Access Compliance Report

Public Rights-of-Way

(Curb Ramps)

Intersection ID: 27280	Main Street: BACK_RIDGE_RD	Cross Street: ELMSTONE_DR	Location: NW
ADA ID: 864AF1010C79	Ramp Type: BlendTrans2	Initial Pass/Fail: Fail	Overall Compliance: No
Codes/Mitigation Info/Possible Solution		Field Measurements/Component Compliance	
Severity Score: 25

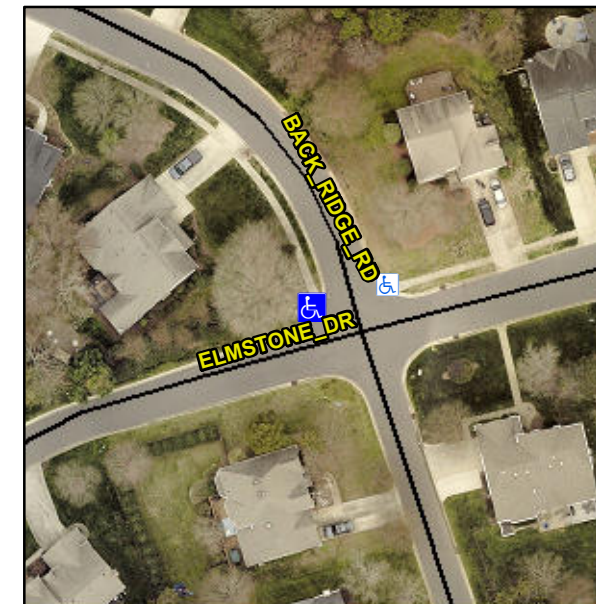
Not Found, R304.5.3

Compliance	Description	Data	Compliance	Description	Data
N/A	Ramp Length (in)	70.0	Yes	BlendTrans Slope (%)	1.8
Yes	Ramp Width (in)	48.0	No	BlendTrans XSlope (%)	9.4
N/A	Flare Type LT	N/A	N/A	Flare Type RT	N/A
N/A	Flare Slope LT (%)	N/A	N/A	Flare Slope RT (%)	N/A
N/A	Flare Traversable LT?	N/A	N/A	Flare Traversable RT?	N/A
N/A	Landing Length (in)	N/A	N/A	DWS Provided?	N/A
N/A	Landing Width (in)	N/A	N/A	DWS Contrast?	N/A
N/A	Landing Slope (%)	N/A	N/A	DWS Length (in)	N/A
N/A	Landing X Slope (%)	N/A	N/A	DWS Full Width?	N/A
N/A	Landing Curb? (Y/N)	N/A	N/A	DWS Offset (in)	N/A
N/A	Shared Landing?	N/A			
N/A	Gutter Ponding?	N/A	N/A	Gutter Slope (%)	N/A
N/A	Gutter Lip Ht (in)	N/A	N/A	Gutter X Slope (%)	N/A
N/A	Painted X Walk1?	No	N/A	Painted X Walk2?	No
	X Walk 1 Direction	To SE		X Walk 2 Direction	To NE
	X Walk 1 Width (in)	N/A		X Walk 2 Width (in)	N/A
	X Walk 1 Slope (%)	2.0		X Walk 2 Slope (%)	7.7
	X Walk 1 X Slope (%)	7.7		X Walk 2 X Slope (%)	4.3

N/A	Ramp inside XWalk1?	N/A	N/A	Ramp inside XWalk2?	N/A
	Road Slope (%)	5.2		Clear Space?	N/A
	Road X Slope (%)	7.6	N/A	Clear Space to XWalk (in)	N/A
N/A	Any Obstructions?	N/A	N/A	Storm Grate/Utility Hazard?	N/A
	Obstruction Type			Storm Grate/Utility Type	
		N/A			N/A
			Yes	Surface Condition? (G/P)	Good
			No	Curb Slope (%)	13.1

Remove & Replace Curb Ramp With Two New Directional Ramps or Equivalent.
